UNITED STATES PATENT AND TRADEMARK OFFICE

Office Action Summary

10/789,615

FINLEY, HENRY EARL

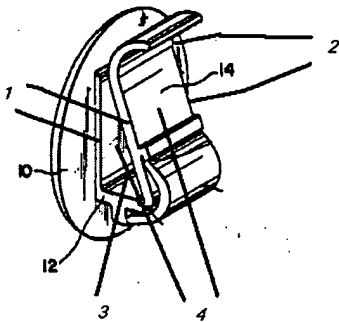
As for Claim 1, Alviti teaches of an ear adornment for adorning an ear of a user, the ear adornment comprising (see accompanying figure below):

a frame member (12) for selectively engaging the ear of the user; and

a sleeve member (10) being removably coupled (the ornament 10 is able to be removed)

to said frame member (12) such that said sleeve member (10) for being positioned adjacent the

ear of the user when the frame member (12) engages the ear of the user, to provide the user with a unique appearance when said sleeve member (10) is coupled to said frame member (12);

wherein said frame member (12) comprises a pair of substantially U-shaped engaging portions (1,2) each having a throat (3) for receiving an upper periphery of the ear of the user, the engaging portions (1,2) each having ends that extend over the ear when said frame member (12) is engaged with the ear, said frame member (12) further comprising a pair of alignment portions (4) extending between corresponding said ends of the engage portions (1,2) to join said pair of engaging portions (1,2) together such that said pair of engaging members (1,2) and said pair of alignment member (4) form a continuous loop.
